# Advisory Design Panel

To: Advisory Design Panel  
From: Graeme Buffett  
Re: 2740 Beach Drive

The November 3, 2020 meeting of the Advisory Design Panel includes a review of a proposed single family dwelling at 2740 Beach Drive in the Uplands neighborhood. The new home would be designed in a contemporary style focusing on glazing to allow for natural light, and utilizing local materials such as stone quarried in BC and red cedar.

SITE PLAN  
 A1.1

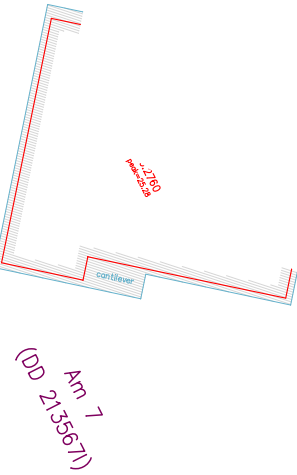
- *Maintenance of the residential park setting.* The proposed principal building, the home, meets all required setbacks. Two accessory buildings are proposed on the north side and the south side of the rear yard. The northern accessory building does not meet the required interior side lot line setback as proposed, and a variance is requested. Currently, the tree resources on site are poor specimens and do not contribute significant tree canopy to the urban forest. The proposal would see the addition of 15 canopy trees planted in a variety of sizes and species. These new trees will further contribute to the residential park setting of the Uplands neighbourhood.

- *Setbacks.* All setbacks are adhered to, with the exception of the north interior side yard due to the siting of a proposed accessory building.
- *Relationship in character and massing to the image of the area and impact on scale and rhythm of development.* The immediate neighbourhood is characterized by a mixture of one and two storey homes in a broad range of styles and ages. The majority of homes in the immediate vicinity are of more traditional forms and styles. The addition of a contemporary designed home will add variety to the neighbourhood. The design of the principal building and proposed landscaping are responsive to the environment.

<p>RESIDENTIAL   DESIGN   COMMERCIAL   MILLWORK</p>	<p>DRAWN BY: SARA BLOKHUIZEN (250) 880 - 5815 SARA@NOVUSPROPERTIES.CA</p>	<p>OCTOBER 21 2020</p>	<p>ACCESSORY BUILDING ELEVATIONS</p>
	<p>A5.1</p>

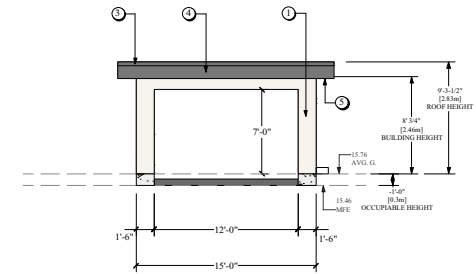
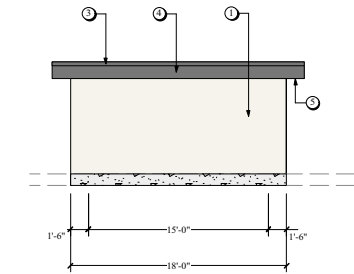
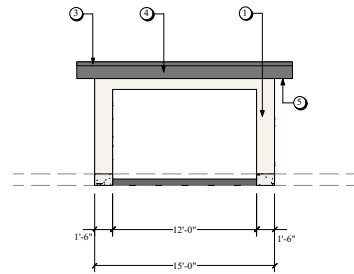
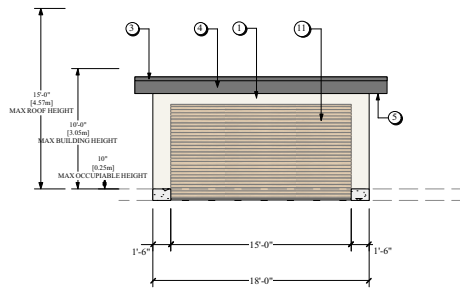
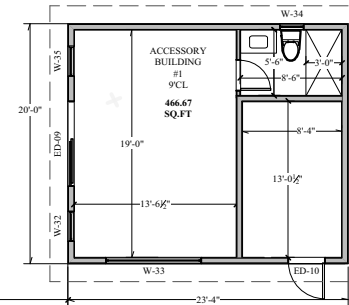
The proposal includes a request to vary the provisions of the District of Oak Bay Zoning Bylaw No. 3531 by permitting a relaxation of the interior side yard setback to accommodate an accessory building located in the rear yard.

<i>Zoning Bylaw Section(s)</i>	<i>Required</i>	<i>Requested</i>	<i>Variance</i>
6.2.4.(2) Interior side lot line setback	4.27 m (14 ft)	1.52 m (5 ft)	2.75 m (9 ft)

- 
- *Overlook and privacy issues.* The home is sited in the centre of the lot with numerous trees and plantings proposed. Windows on the second storey of both of the side elevations are primarily of the clerestory type, mitigating issues of overlook.
  - *Transition between private and public space.* Currently the site is bordered along the street by a low stone wall. This wall would be removed and a landscape berm installed. The front yard would consist of a vast planting area, driveway and walkway leading to a cantilevered covered entrance.
  - *Accessory buildings.* The accessory buildings have been sited in the rear yard and finished to match the home.

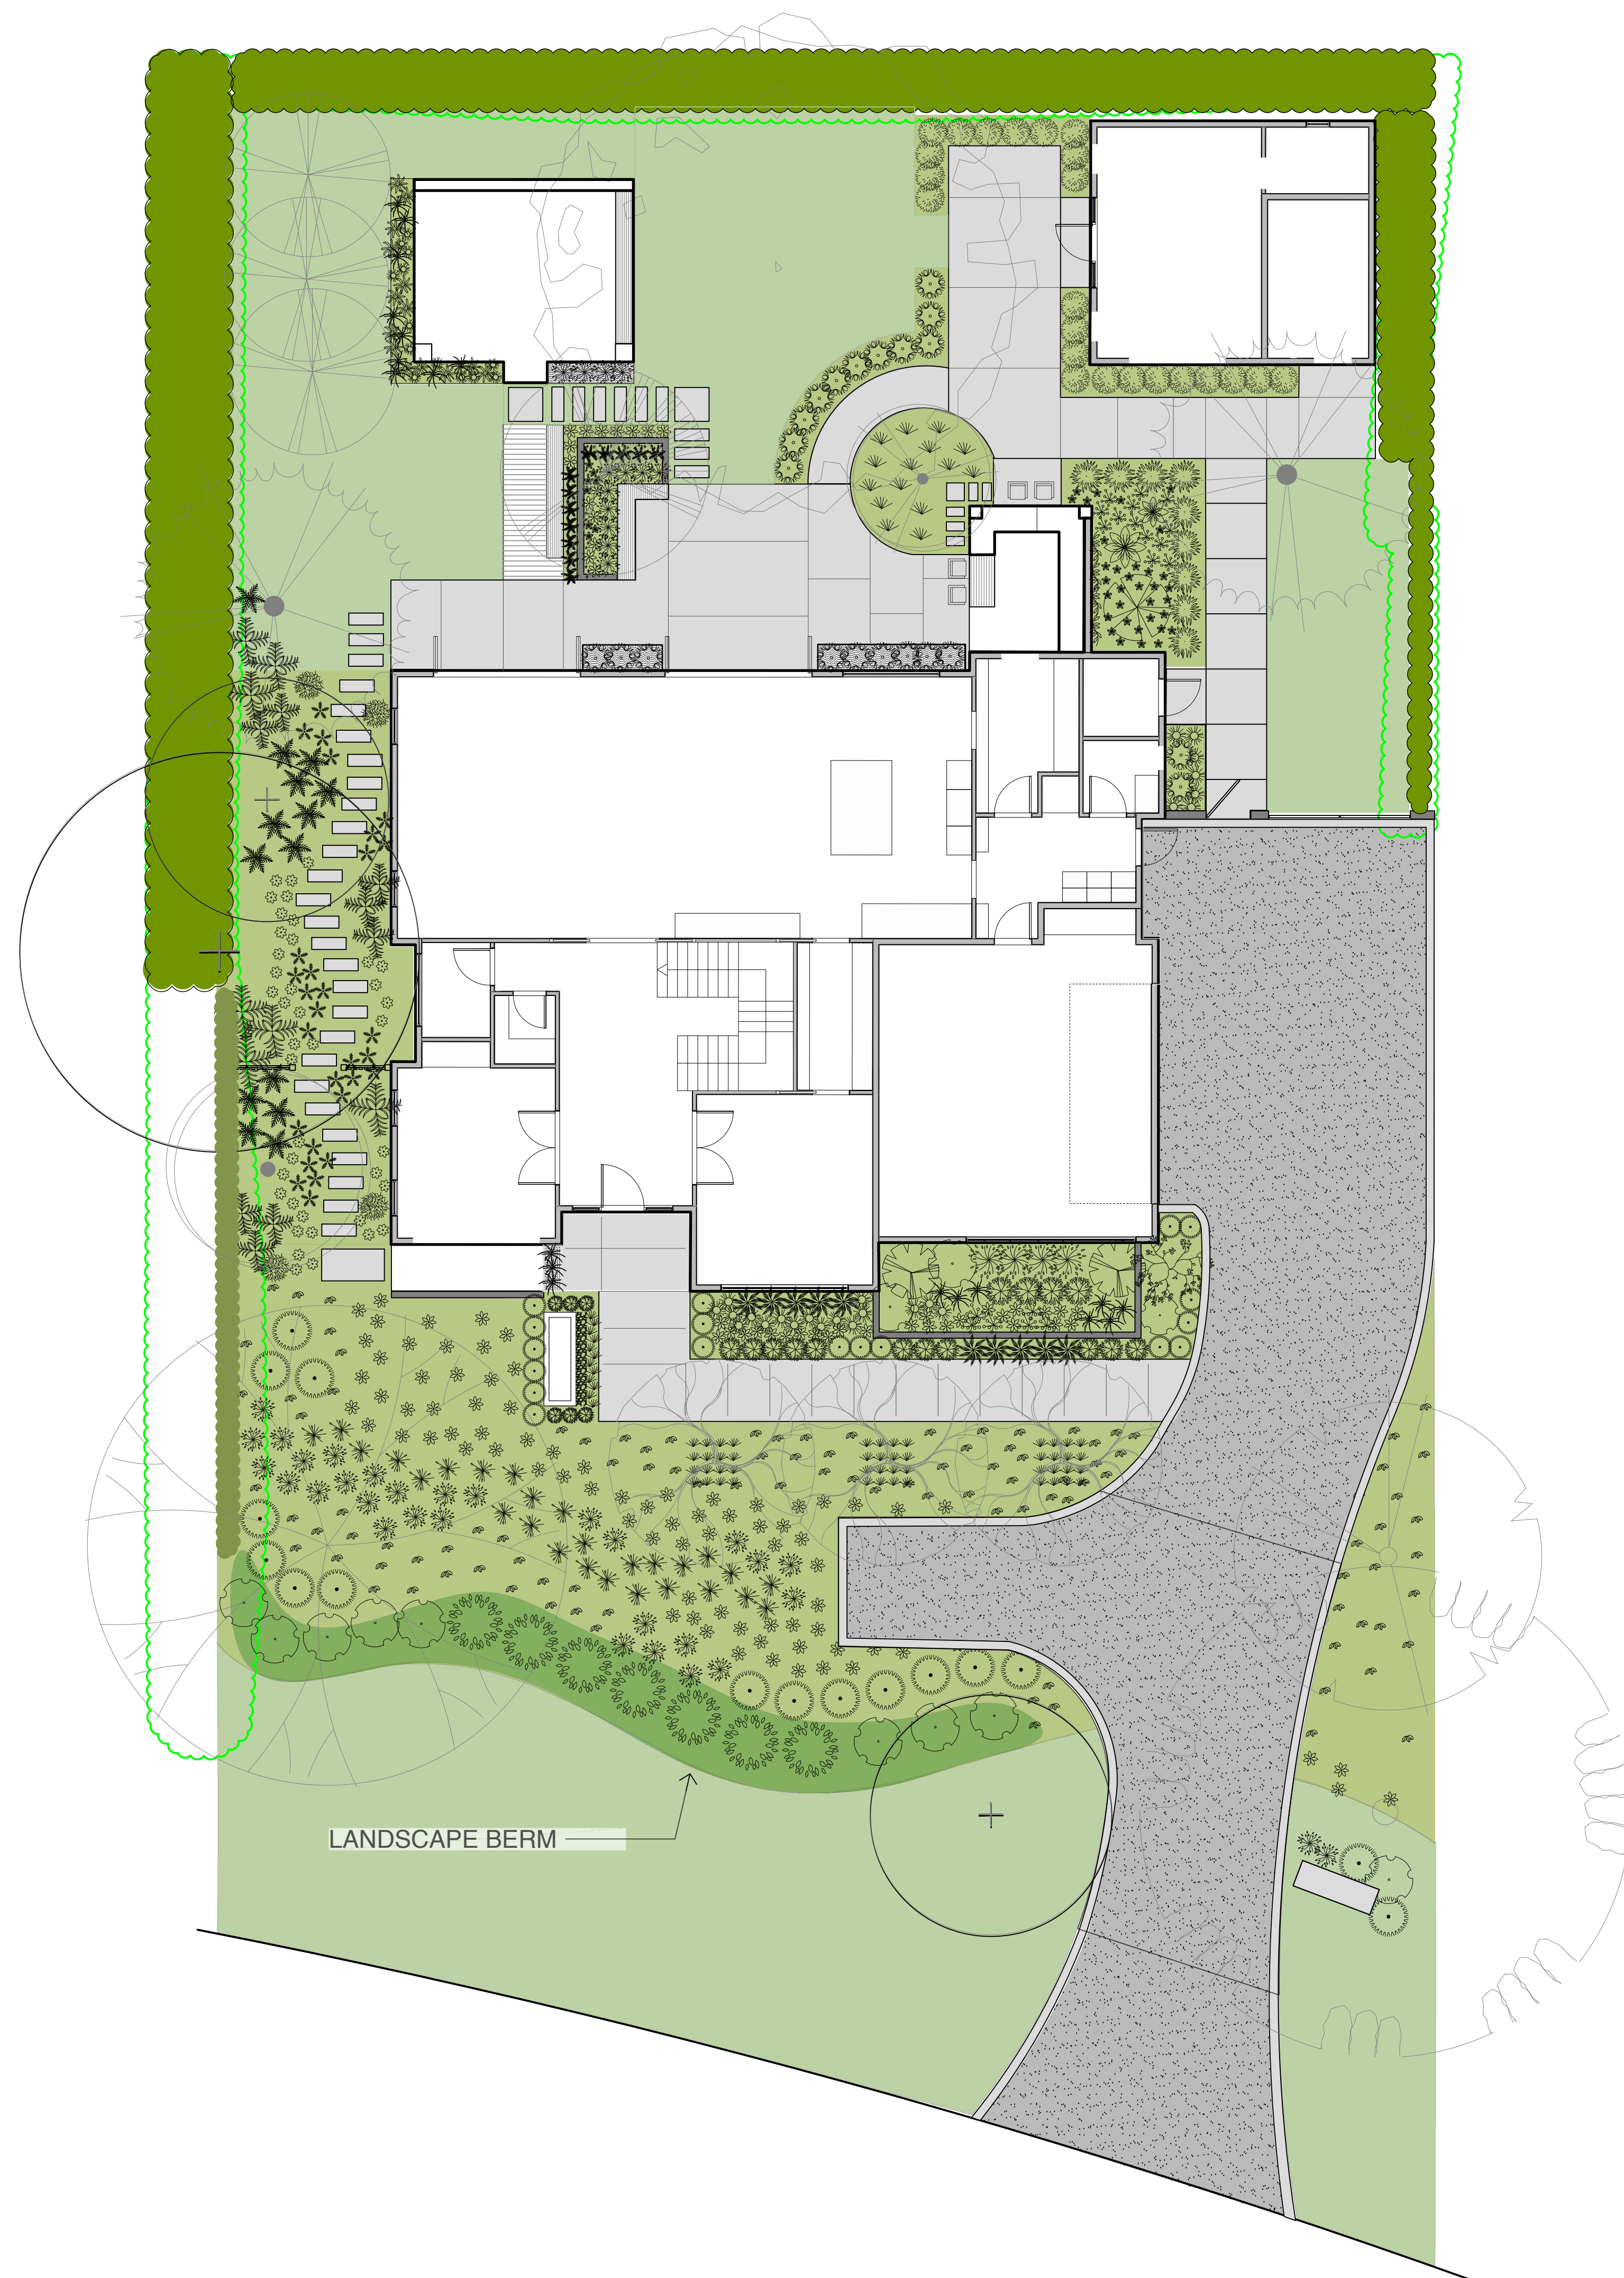
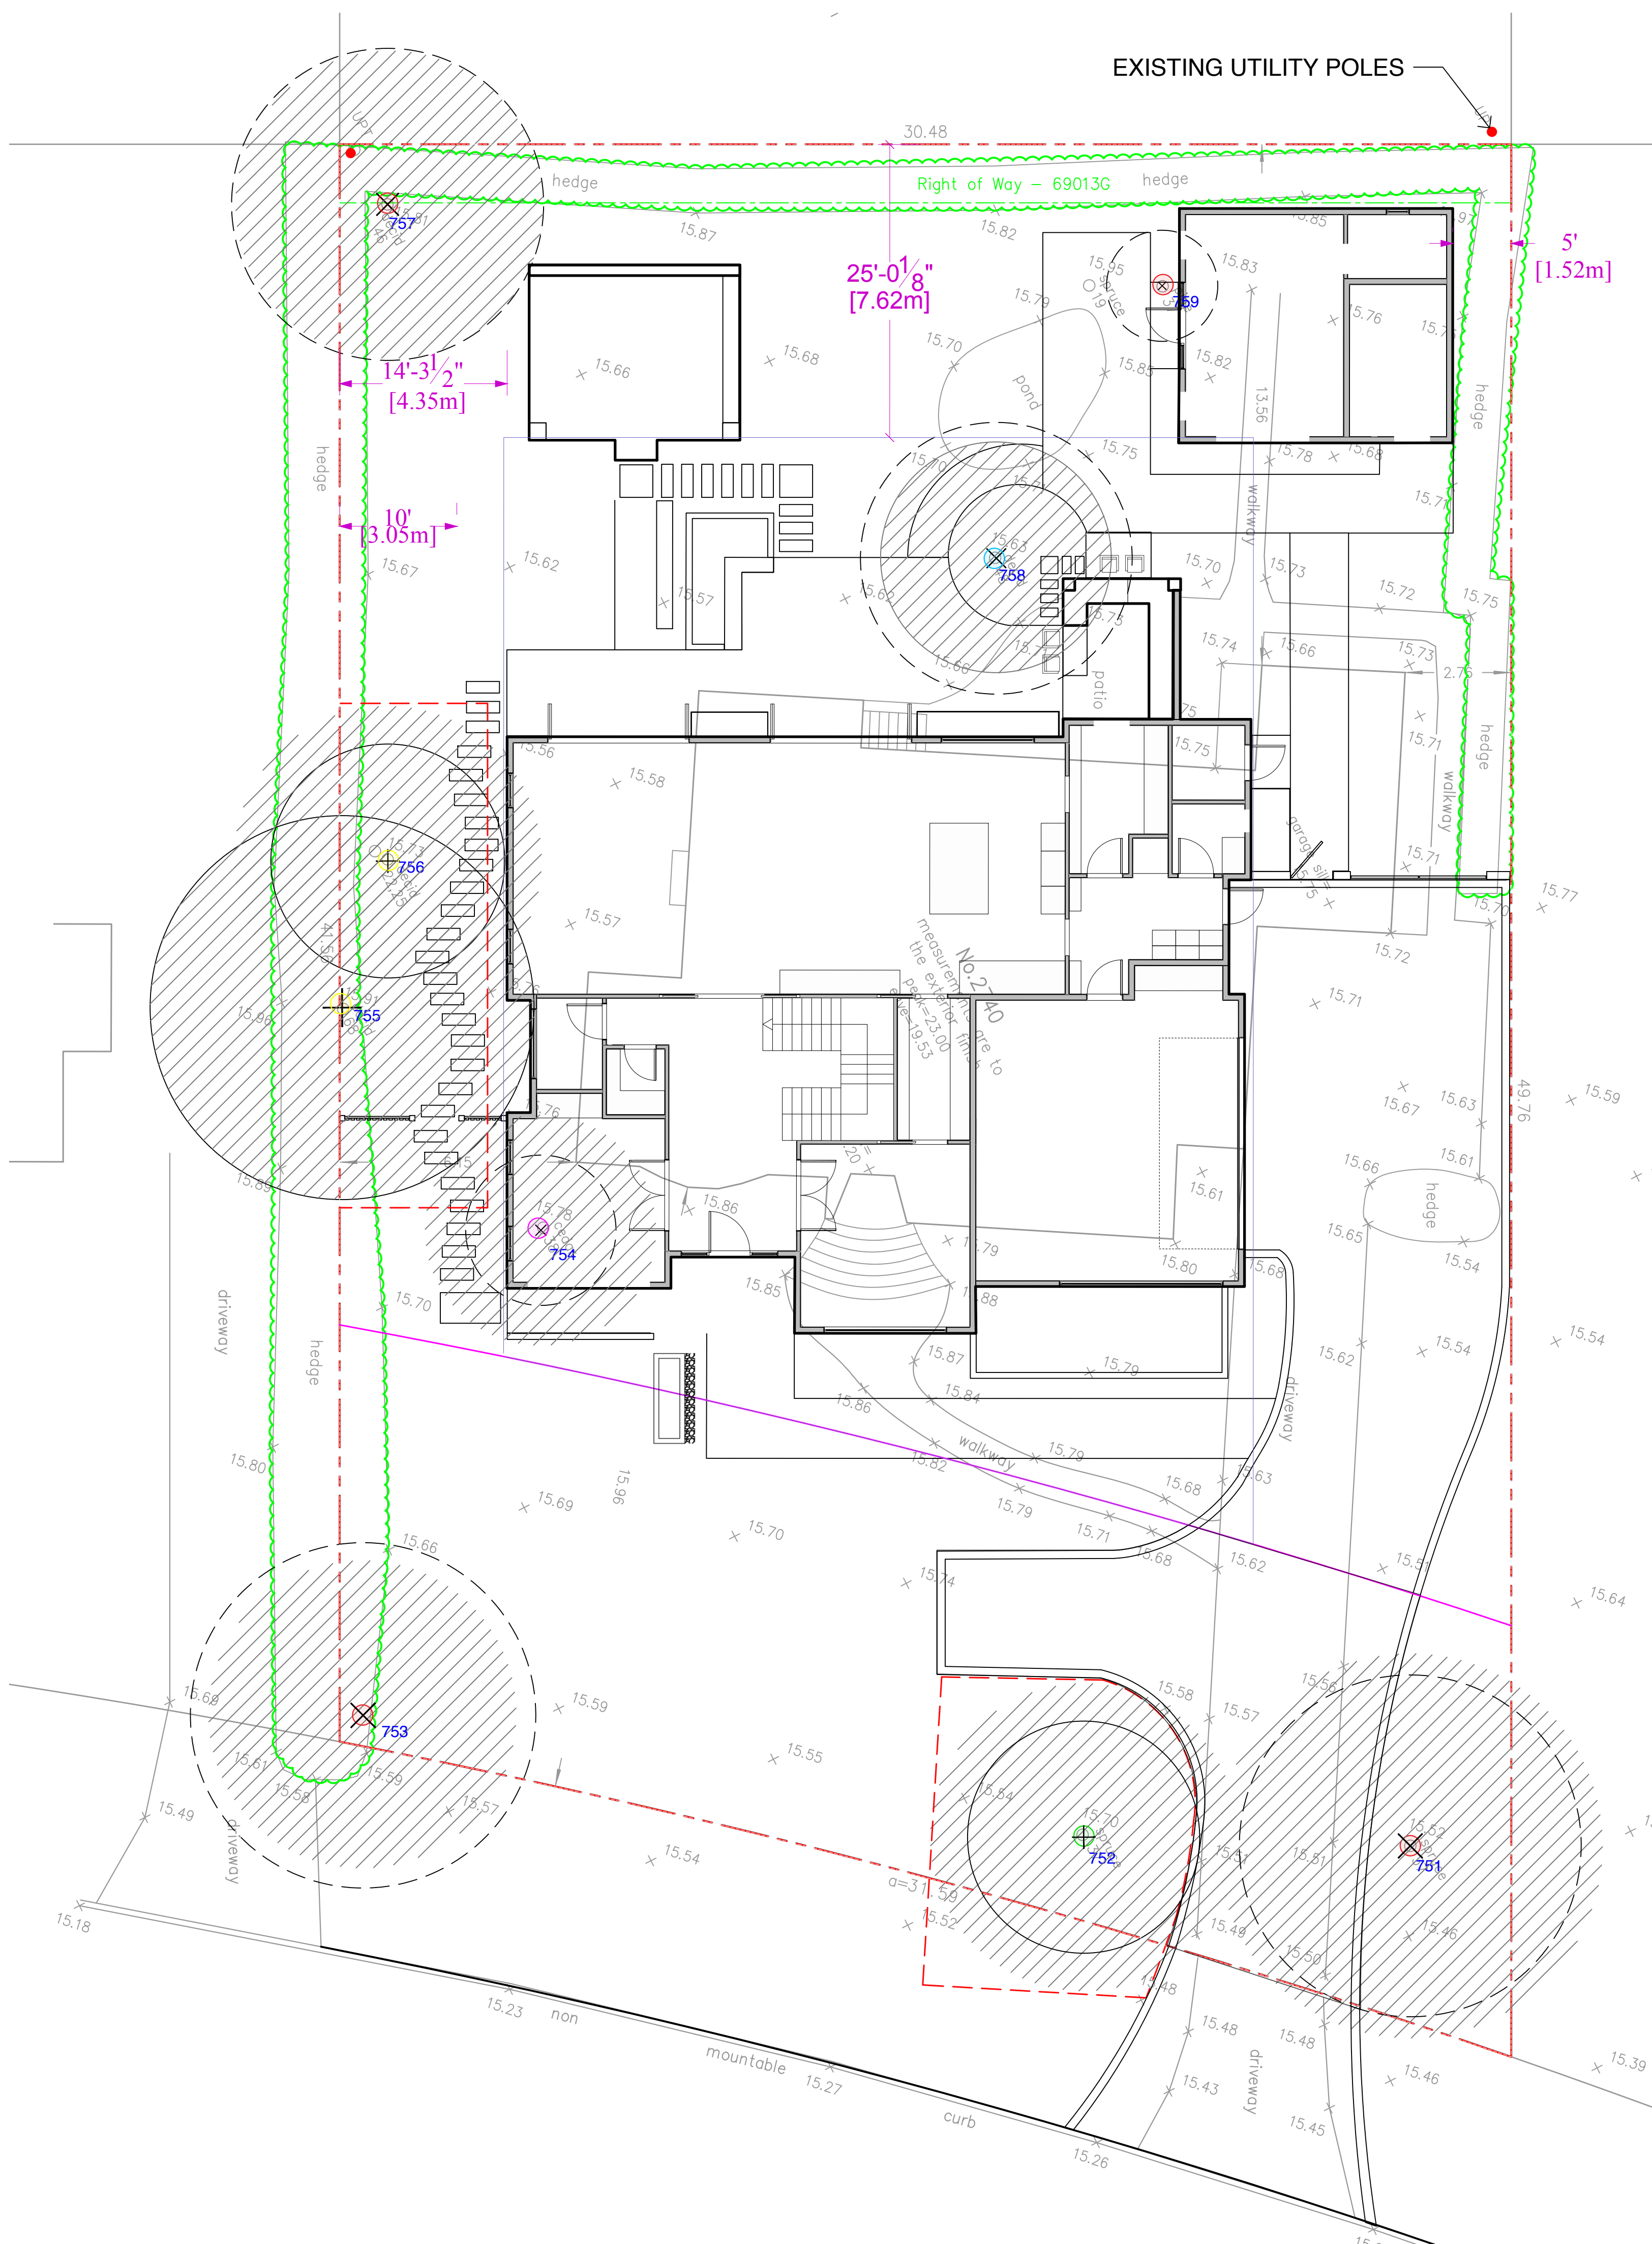
The property has a number of protected trees on it, four are to be removed, one for construction and three due to poor condition or poor species. A cedar shrub near the house and a multi-stemmed magnolia near the patio will be removed, they are not counted as protected trees. None of the trees being removed are significant in the current landscape. The remaining trees will require protection as outlined in the report.

As outlined in section 10.1, each of the trees to be removed for construction will require a bond of \$1000 and have two trees planted to replace it. Each of the trees removed for poor condition will require a bond of \$500 and one tree planted to replace it. If all the removals are approved, 6 new trees will have to be planted.

As outlined in section 10.4 canopy cover securities will be taken to promote tree replanting. The canopy cover requirement for this property is 45%. I calculate the starting canopy cover at approximately 6%. 540 square meters of canopy cover will be required to reach the target. This would require a minimum of 5 trees to be planted. Bonds will be taken at the rate of \$500 per tree to be planted based on large canopy trees. Canopy shortfall will forfeit bonds at the rate of \$500 per large tree required to meet the target. The landscape plan shows the planting of 15 new trees of various sizes that will provide a total of 675 square meters.
